Summary of Items Discussed in 1/2021 APSEC Discussion Forum on 22 January 2021

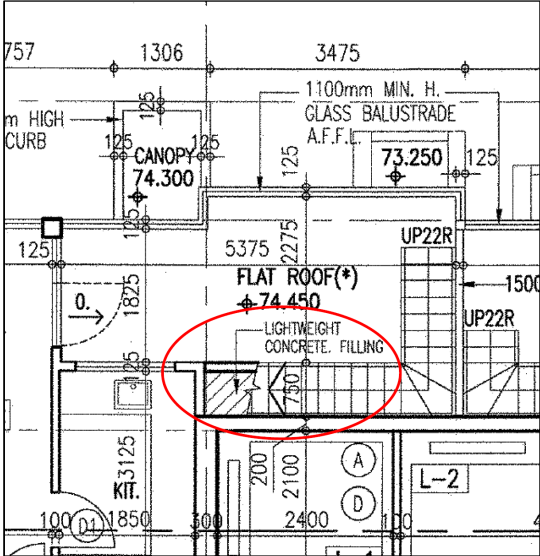
Items proposed by Convenors for Discussion	Summary of Discussion and BD's Response
	Items raised by HKIA	
1.	<p><u>Disposition of AC Platform Combined with Balcony and/or UP</u></p> <p>According to BD's response to item 9 of ADF 3/2020 held on 29 September 2020, the length of the 400mm working space should not be less than that of the <i>AC platform</i>.</p> <p>However, as per item (d) of Appendix B to the CoP on Design for Safety – External Maintenance 2019 (Dfs Code), it is stated that "<i>The length and depth of the working space should be not less than the length of the AC and 400mm respectively</i>", in lieu of the length of the <i>AC platform</i> as noted in the above BD's response.</p> <p>We appreciate if BD would further clarify on this.</p>	BD advised that the 400mm working spaces should be provided in front of the whole area of the A/C platform to facilitate maintenance of the AC unit.

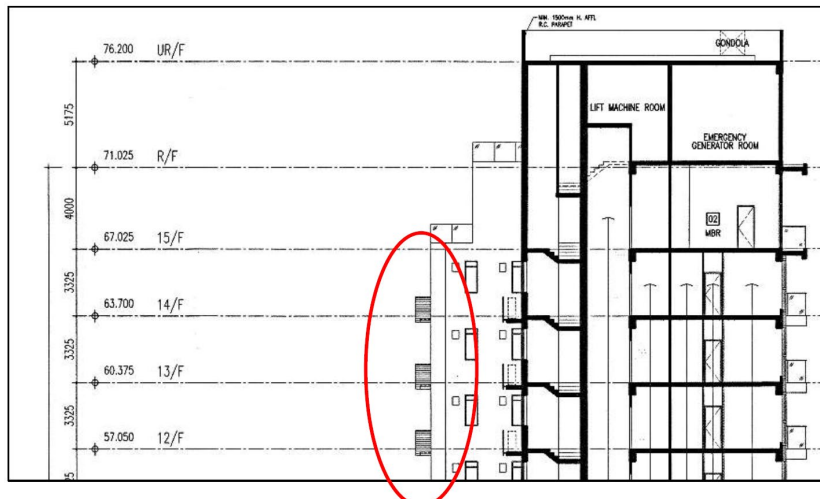
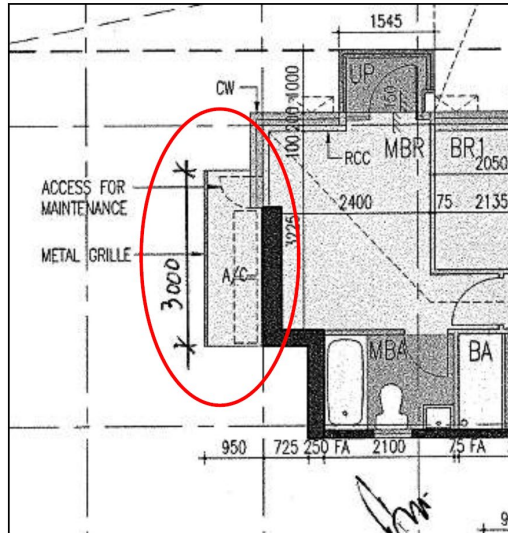
2.	<p><u>Design of Protective Barrier of AC Platform Combined with Balcony and/or Utility Platform</u></p> <p>According to BD's response to item 17 of ADF 3/2020 held on 29 September 2020, full height solid wall design abutting the AC platform was considered not acceptable, taking into account the different designs in intake and exhaust system of AC available in the market.</p> <p>In order to cater for the intake and exhaust system of different AC available</p>	In light of the provision of a ventilation gap of not less than 100mm, BD advised that the proposed arrangement was considered acceptable.

<p>in the market, we propose a clear distance of not less than 100 mm be allowed between such AC platform and the full height solid wall as follows:</p>  <p>Would BD please clarify if the proposed arrangement is acceptable?</p>	
<p>3.</p>	<p><u>AC Platform for Non-Domestic Portion</u></p> <p>According to item (h)(ii) of Appendix B to the CoP on Design for Safety – External Maintenance 2019, for the purpose of exclusion from GFA calculation, individual AC platforms must not be erected at the external walls of the building where AC platform combined with balcony and/ or UP (the “combined features”) are provided.</p>	<p>BD advised that the concerned requirement under item (h)(ii) of Appendix B to the DfS Code is applicable to the entire development (i.e. including the non-domestic portion of a composite development). From M&R access point of view, AC plant room and/or AHU room, which could be disregarded from GFA calculation under Building (Planning) Regulation 23(3)(b), would be a more preferable option.</p>

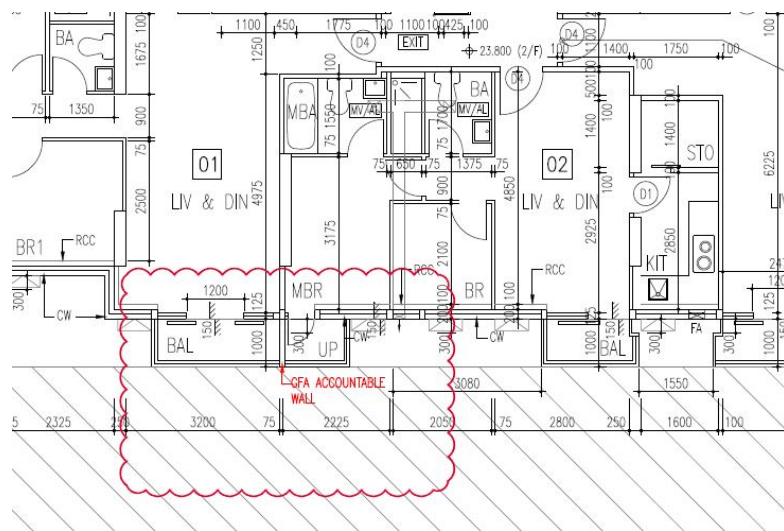
Items raised by HKIS	
8.	<p><u>GFA Calculation for Space below Open Staircase to Roof</u></p> <p>In some of the projects, private open staircase is proposed for the residential flat on the top floor to its private roof on top. In the past, if the space below the staircase is filled with light-weight concrete, there would be no accountable GFA for that space. However, recently, it is required to include in GFA calculation even such space is filled with light-weight concrete as illustrated in the diagram below. Would BD please clarify.</p> 	<p>BD advised that the external staircase such as circular one without solid risers and enclosure wall(s) would not be required to be included in GFA calculation. The whole covered area of an external staircase with solid raisers or enclosure wall(s) should be included in GFA calculation unless the space below was filled with lightweight mass concrete.</p> <p>As the space below the open staircase shown on the sketch was filled with light-weight concrete, it was considered not accountable for GFA calculation.</p>

10. **Separation Between Utility Platform and Balcony**

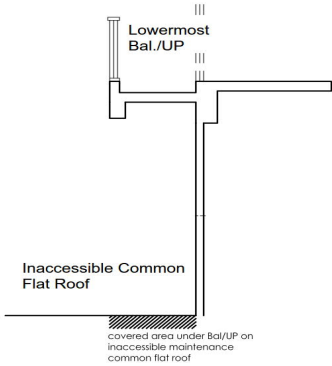
Referring to paragraph 1(b)(v) in Appendix A to JPN 2, an utility platform (UP) is required to be at least 1.5m away from a balcony. From our understanding, the rationale is to prevent abuse by combining the UP and balcony. Therefore, it is opined that this requirement should only apply to the UP and balcony of the same residential unit. In other words, the UP of one unit being located immediately adjacent to the balcony of another unit should be permitted. Please confirm if our understanding is correct as illustrated in the below sketch.

BD advised that the 1.5m separation requirement between the UP and Balcony was applicable to the adjoining units. Consideration would be given on case basis taking into account the chance of abuse. To this end, the proposed layout as shown on the sketch was considered not acceptable as the separation of UP and balcony could be easily removed.
